January 11, 2000

SUBJECT: COMMENTS ON THE IMPORTANCE OF CHEMISTRY IN THE NEAR FIELD  
TO DOE's YUCCA MOUNTAIN REPOSITORY LICENSE APPLICATION

## CHEMISTRY IN THE PROPOSED YUCCA MOUNTAIN REPOSITORY NEAR FIELD

Figure 1. Waste Package and Drift Design Cross Section

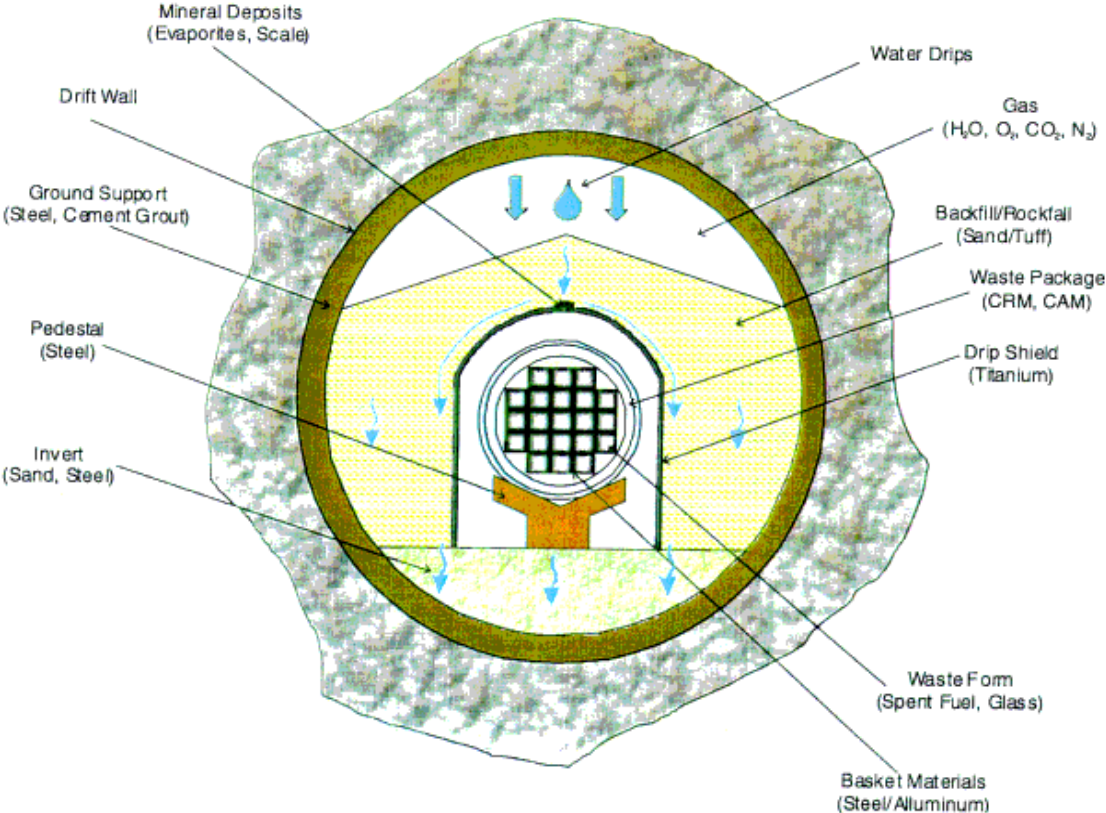
The current waste package design is shown in cross section Figure 1. The outer container has a 2 centimeter-thick wall of alloy C-22, whose composition is given in table 3. The inner container has a 5 centimeter-thick wall of stainless steel. It is expected that the stainless steel will corrode much faster than the C-22 once water breaches the C-22, and that in times far shorter than the repository licensing period it will be completely oxidized provided that the C-22 is in fact breached. As noted above, this steel could produce locally reducing conditions in the waste package or drift, and if oxidized, will add to the ionic iron content of the water. (Iron corrosion products would occupy more volume than the stainless steel from which they come, leading to potential adverse mechanical and structural effects. However, these effects are not considered here.) Unlike the steel in the waste package support and the steel invert, the iron ions from the stainless steel in the waste package container will be available for chemical reactions with the waste form itself at the water-waste interface.

There are extensive sources of information and data on the corrosion of high-nickel alloys, some of which are similar to C-22 (Betteridge, 1984; Schweitzer, 1996; INCO Inc., 1969 and 1995), but none for anything approaching the lengths of time being considered for the lifetime of the waste packages. The corrosion data that do exist for C-22 are very encouraging. However, pit, crevice, and stress corrosion are still matters of concern, and a better understanding of the mechanisms involved in these corrosion processes is needed before credit can be taken for the very long-term protection that DOE may postulate in its LA.
